ADDENDUM NO. 01
January 13, 2022

To Drawings and Specifications dated December 17, 2021

CLINE ELEMENTARY SCHOOL CAMPUS REPLACEMENT
FOR FRIENDSWOOD I.S.D.

Prepared by: PBK
11 Greenway Plaza, 22nd Floor
Houston, TX 77046-1104
PBK Project No: 20380

2 TYPICAL DETAIL FOR SUBGRADE PROFILE BELOW SLAB-ON-GRADE
NO SCALE

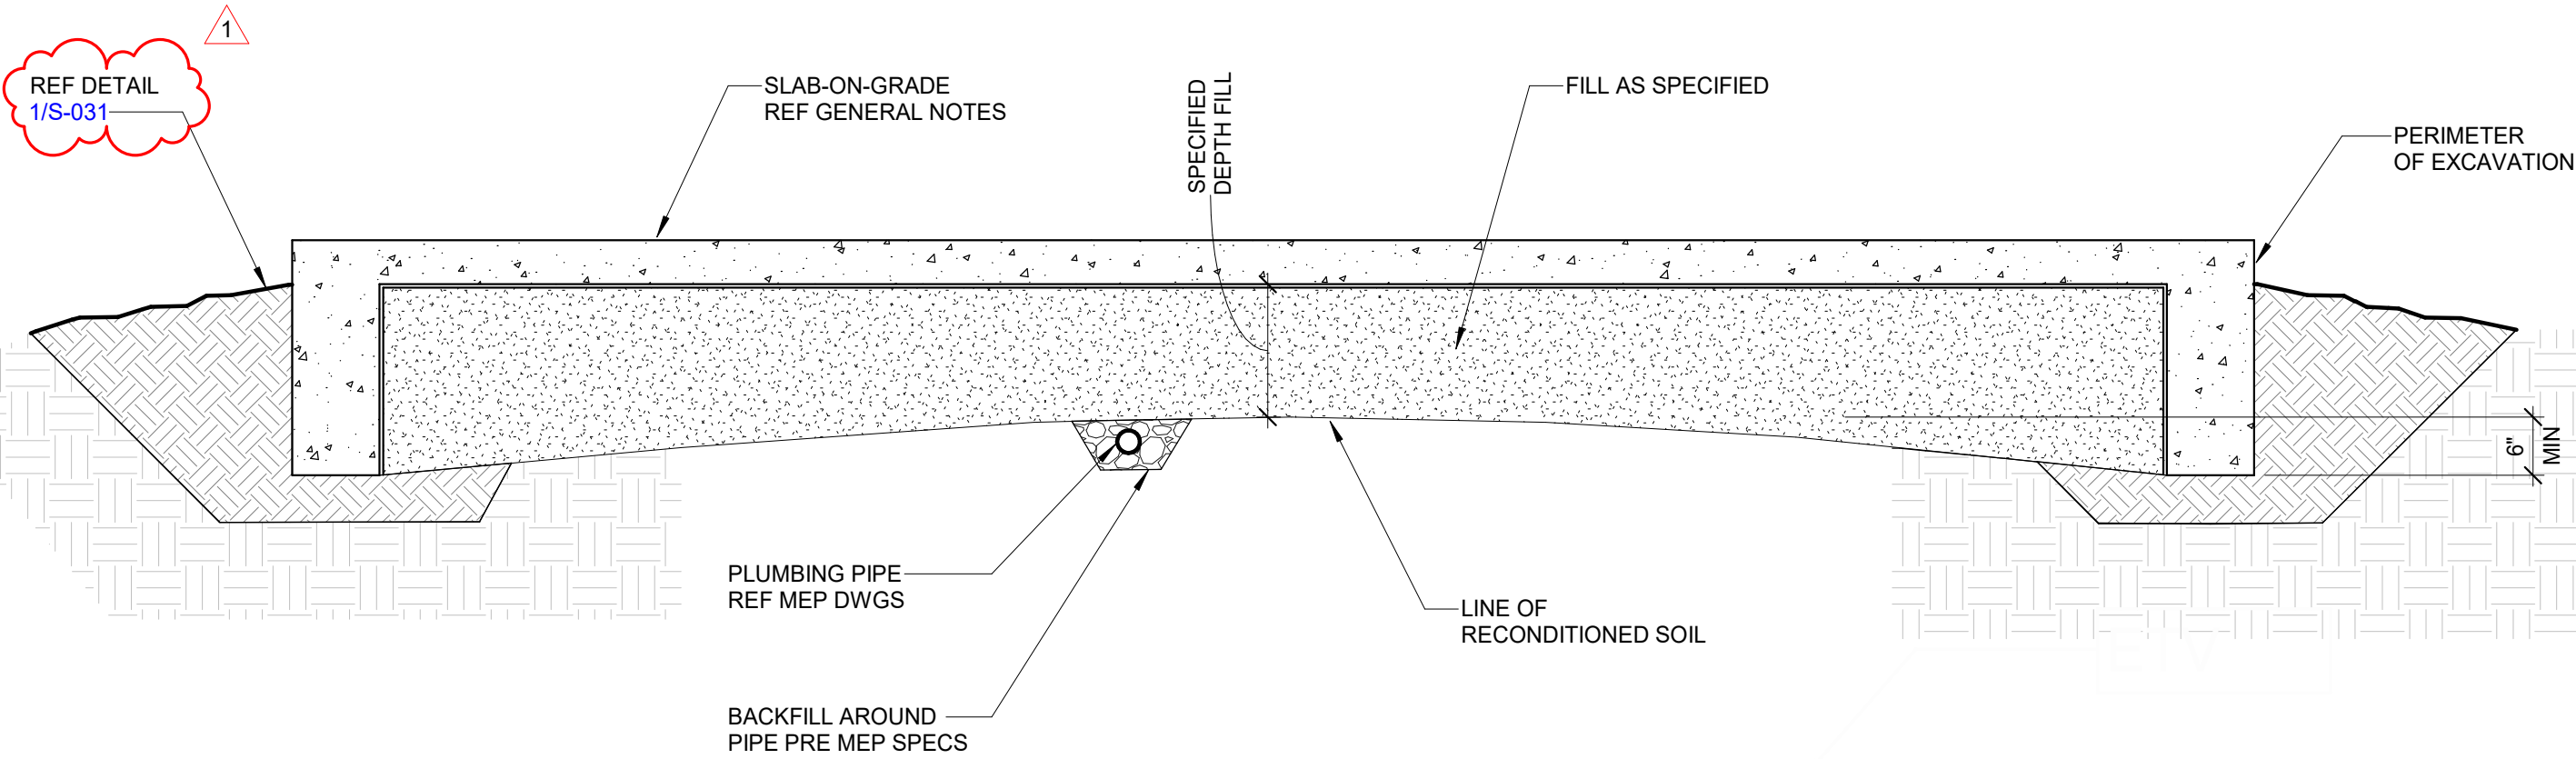
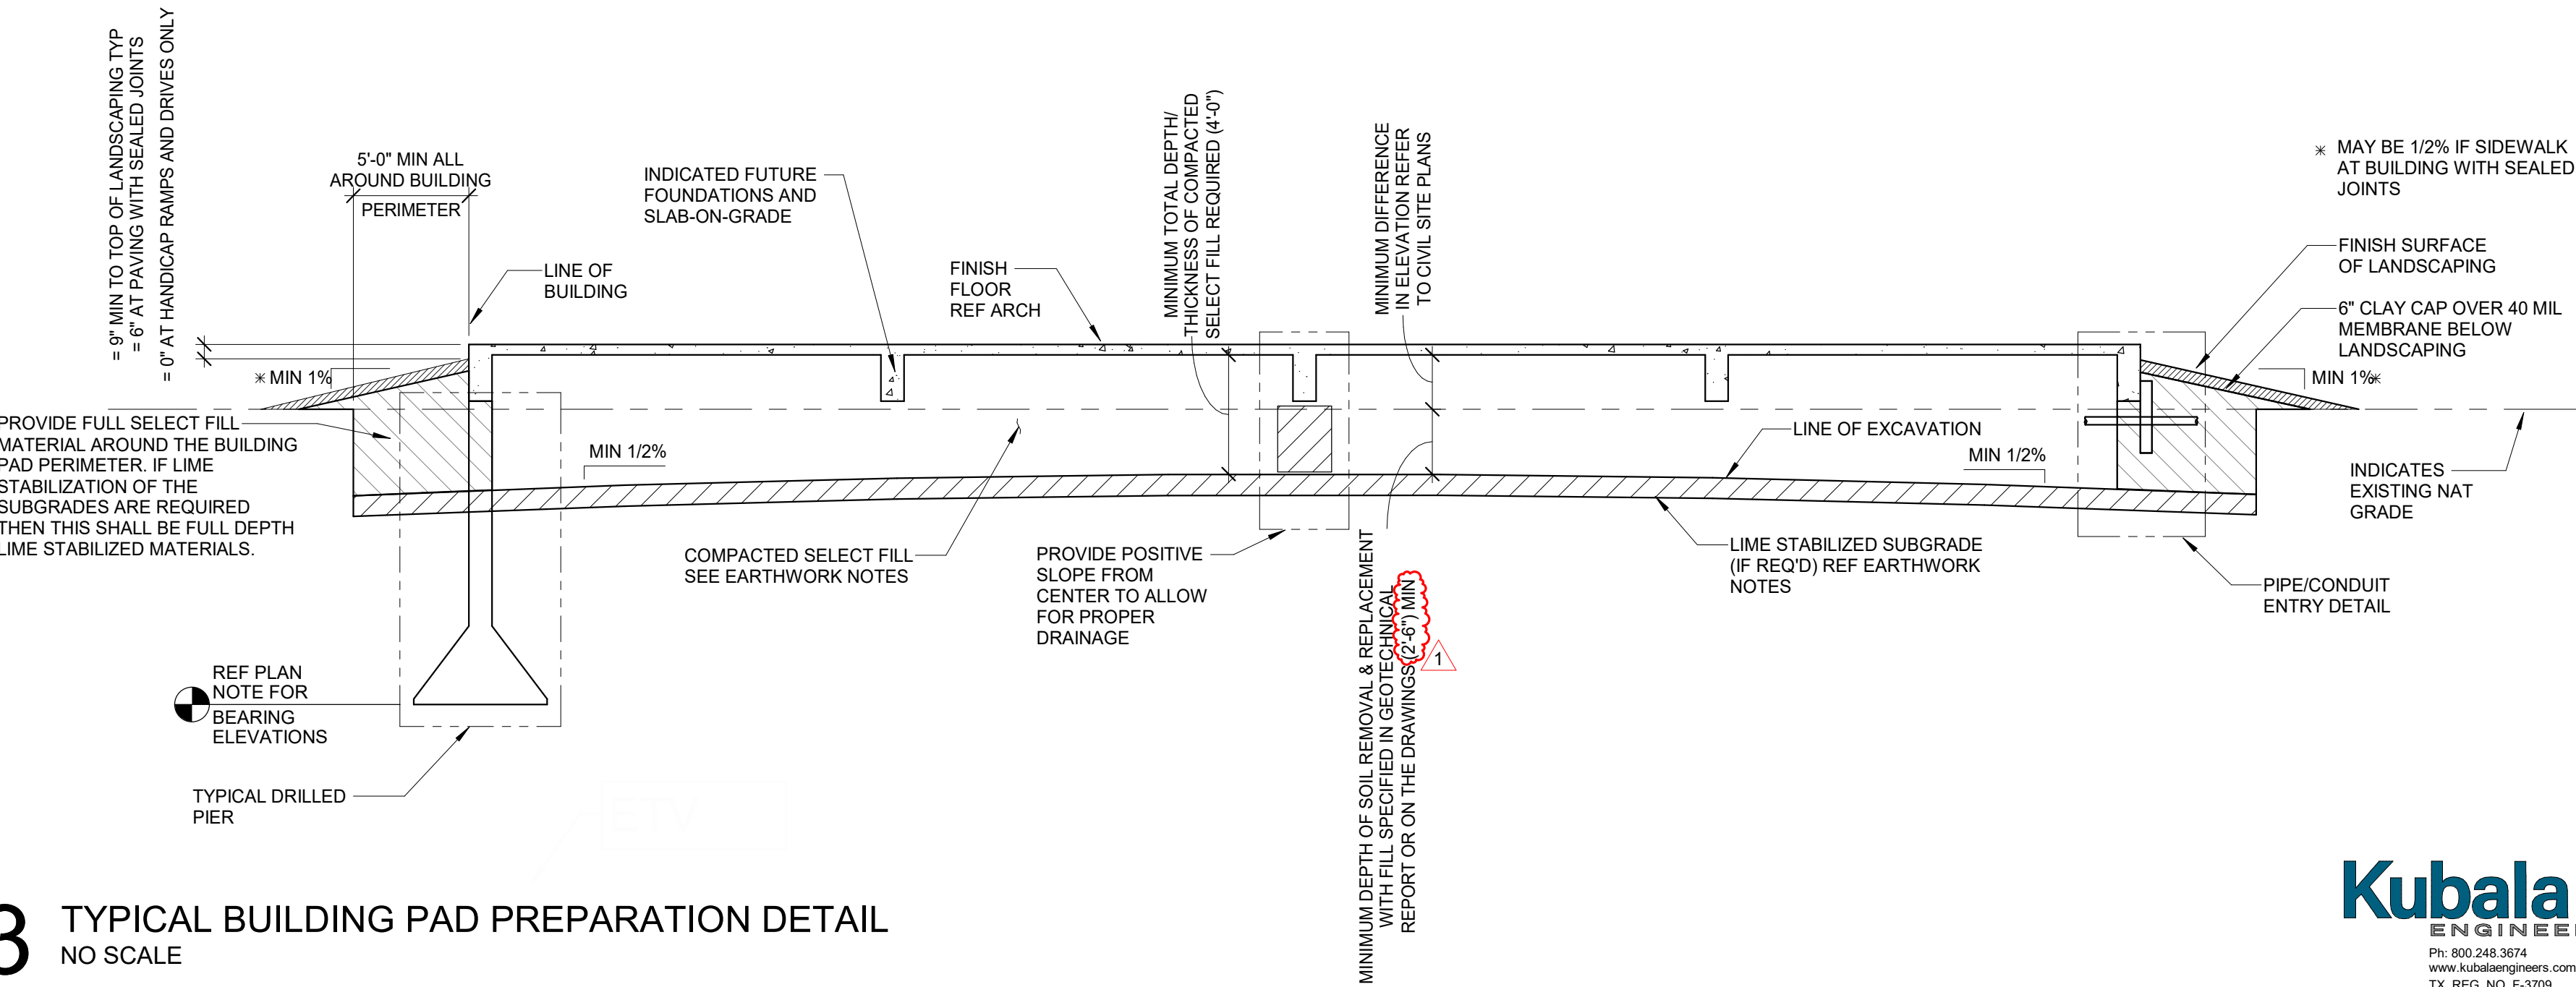
- Item No. 18 Reference detail 2 on Sheet S-030. A note indicates for there to be a Clay Cap on the perimeter of the slab on grade. Subgrade Preparation Note 5 requires select fill at the perimeter of the slab on grade. Please define extent and depth of clay cap if it is required. Is this to be the top 1 foot of soil extending 10' out from building slab, above the select fill? Will this affect the depth of select fill outside perimeter of slab? Please advise.
Refer to revised S-030 sheet.

- Item No. 19 Reference Subgrade Preparation Note 1 on Sheet S-030 and Note 15 on Sheet S-030. These notes imply that lime stabilization might be required at the building pad and that the contractor is to submit an allowance pricing for such. There is no place on the proposal form or alternate Proposal form to submit the pricing for this lime stabilization allowance. Please advise.
Refer to revised S-030 sheet.

- a. General Foundation Note 1 updated. See revised sheet.
- b. General Foundation Note 5 added. See revised sheet.
- c. Subgrade Preparation Note 5 & 14 revised. See revised sheet.
- d. Subgrade Preparation Note 15 removed.
- e. Detail 2 & 3 revised. See revised sheet.
